APPLICATION FOR URBAN DESIGN COMMISSION REVIEW AND APPROVAL

AGENDA ITEM#	
Project #	
02319

RE: Hilldale PUD-GDP-SIP Amendment #2

JFA RESPONSE TO URBAN DESIGN COMMISSION CONCERNS HILLDALE SHOPPING CENTER – AMENDED PUD (GDP-SIP): SIP #2

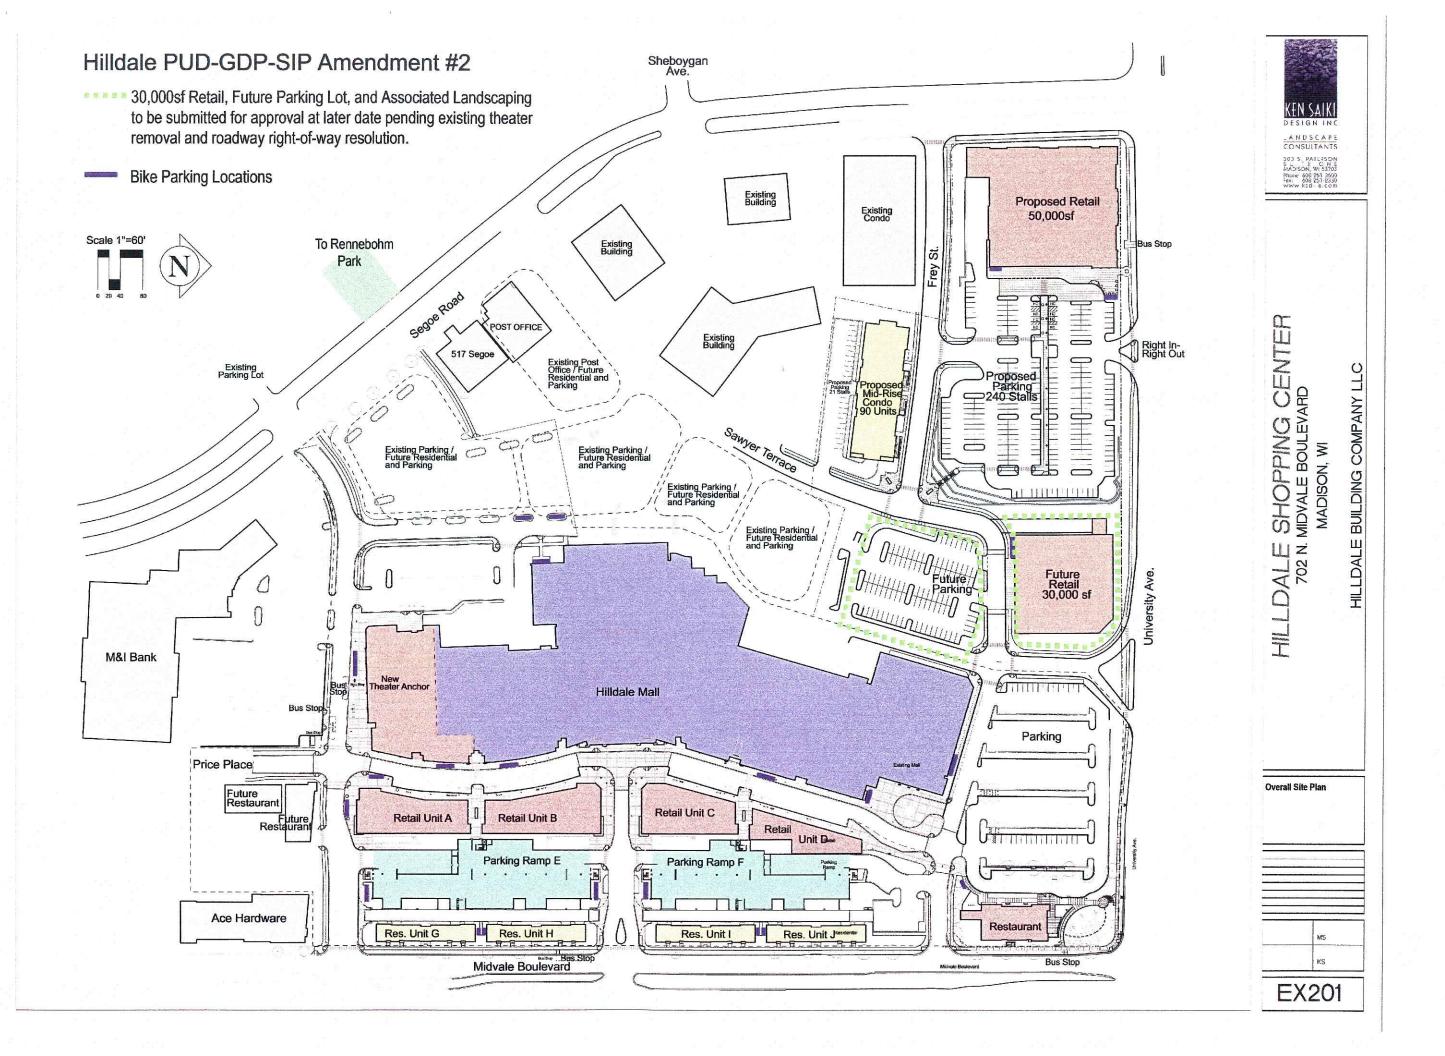
CONCERNS: STORM WATER MANAGEMENT PLAN AND CONCEPTS

- The storm water management plan was not provided
- Impacts on potential for flooding from extensive hard surface
- · Rain gardens or other infiltration opportunity areas are needed

- The storm water management plan has been provided for the entire center with the SIP #2 area shown for this submittal.
- The proposed development will increase the impervious area of the site by approximately 6% but will increase the permeable and green space area by 16%. There are currently no stormwater management measures utilized on site to treat stormwater runoff from these areas.

- Stormwater management measures are proposed for the redevelopment and include the following;
 - O Approximately 50% of the rooftops will be constructed as a "green roof". This will provide stormwater detention and stormwater runoff volume reduction over an area of approximately 0.6 acres.

- o Drain tiles will carry rainwater from the roof to vegetated areas throughout the site. This will provide opportunities for stormwater re-use.
 - o Porous pavers will be utilized at low points in the parking lot.

- O At least 5 "infiltration islands" will be installed throughout the lot. This will provide infiltration opportunities and peak volume reduction over an additional area of approximately 0.1 acres.

- o An underground detention storage system will be installed to impound excess stormwater runoff and release it to the City drainage system at a controlled rate.

- The net result of these measures is an expected reduction in the peak discharge rate, stormwater runoff volume, and TSS loading which will meet or exceed City of Madison, Dane County, and Wisconsin DNR Stormwater Management Requirements

Section C-C'
Frey Street to Whole Foods loading dock

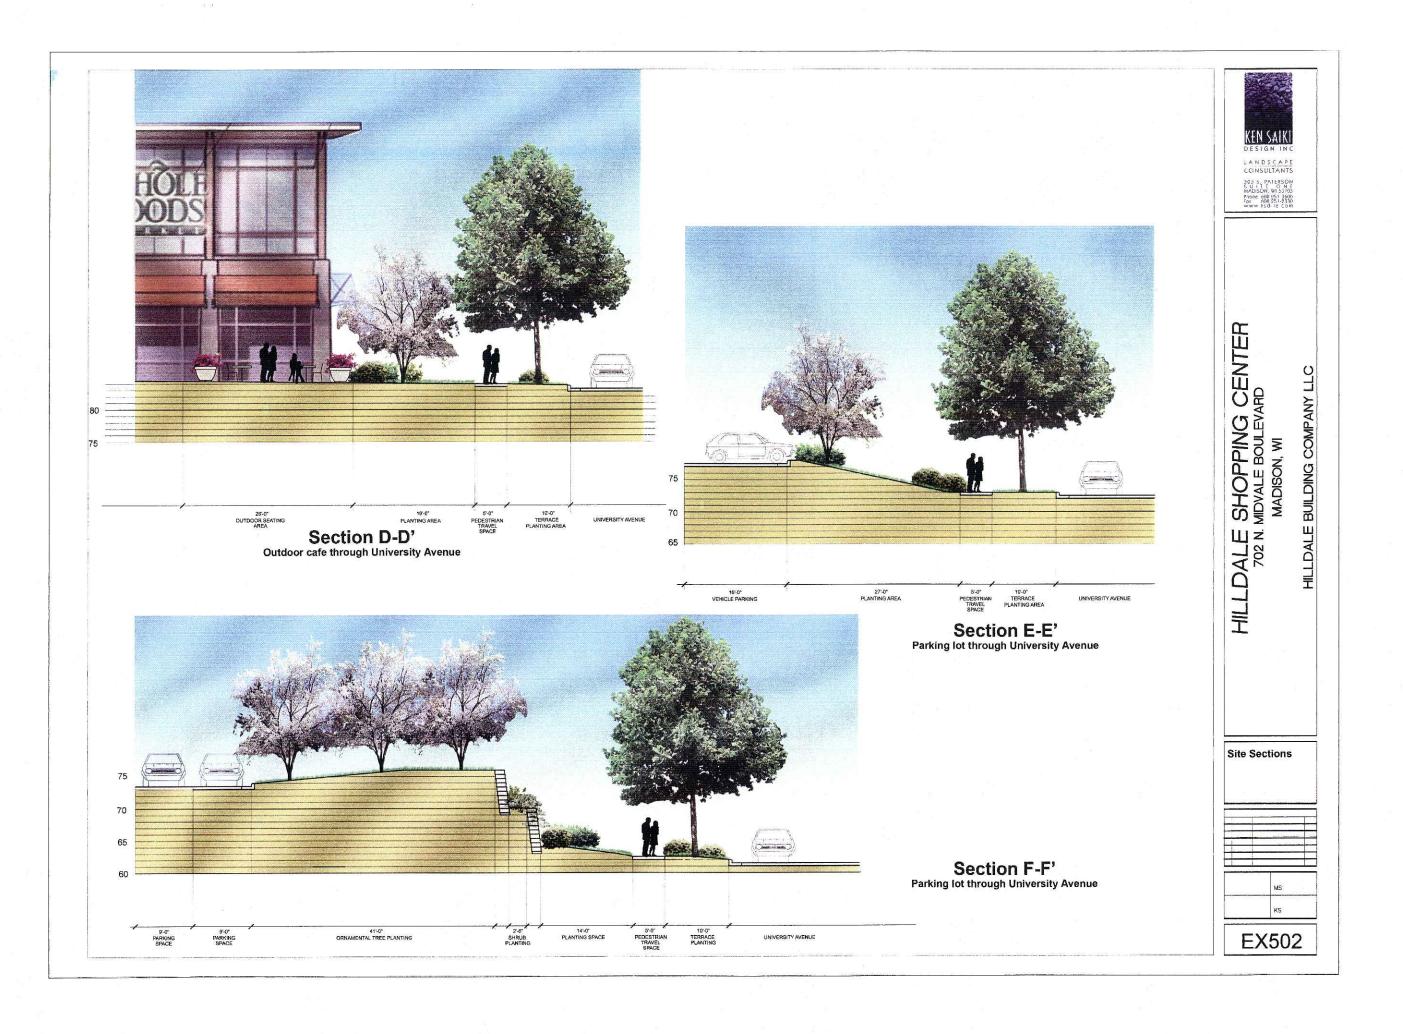
CONCERNS: LOADING FACILITIES - WHOLE FOODS MARKET

- Consider relocation of the loading docks to reduce noise and view impacts.
- Consider in-place features to attenuate loading dock noise and to hide the loading operation
- The proposed trellis is an inadequate solution.

- The loading dock for the Whole Foods market remains in place on the south side of the building. Adequate screening and noise attenuation can be much more successfully implemented on the south side of the grocery building. The existing grade on the south side allows the loading dock to sit below the pedestrian grade.

- The existing grade on the north side would not allow for a pleasant presentation to the heavily traveled University Avenue.
- A roof has been designed to cover the loading dock and will also be covered with vegetative "green roof" material.

- A higher retaining wall and enhanced landscaping and screening along Frey Street have been provided between the loading dock and the sidewalk.
- Whole Foods Market will manage the operation of its loading area for minimal impact on the adjacent community:

Isometric view of the proposed Whole Foods Market and green roof assembly

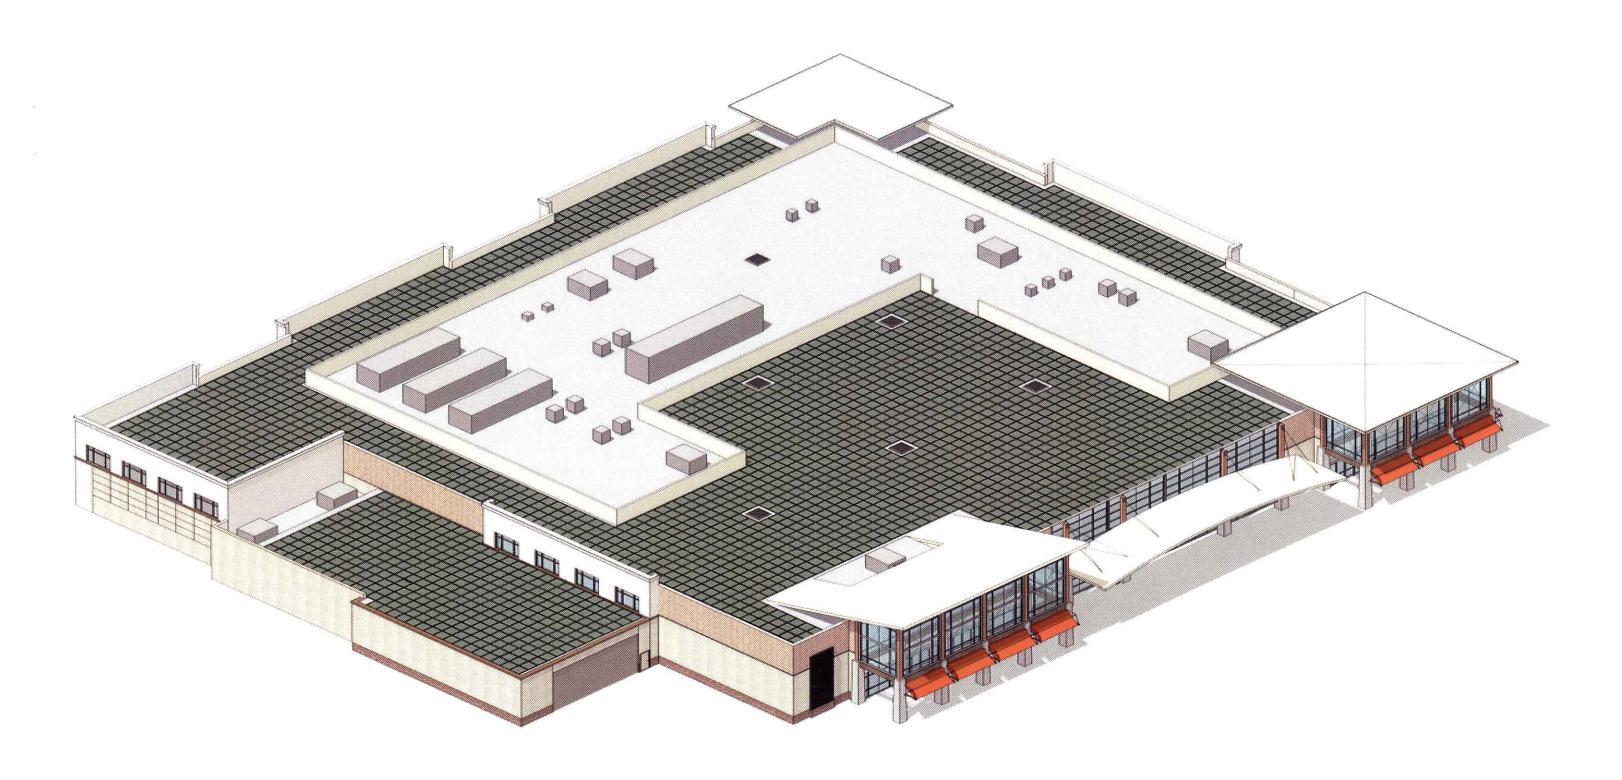
CONCERNS: ROOFTOP CONDITIONS AND APPEARANCE – WHOLE FOODS MARKET AND CONDOMINIUM BUILDING

- Consider a green roof for both buildings
- Consider rooftop deck for the condominium building.
- Consider residential uses above the grocery store.
- Consider what the roofs will look like from Westin Place?

- The roof areas of the Whole Foods Market building <u>and</u> the condominium building have been re-designed to provide 40% 50% coverage with vegetative "green roof" material.
- Rooftop mechanical equipment on the Whole Foods Market has been appropriately arranged behind screening, and the mechanical penthouse on the condominium building has been enclosed and covered.
- A roof deck would increase the height of the elevator stack in the condominium building and is not
 economically viable or warranted for this product.
- Isometric views of both roofs have been provided in this submittal.
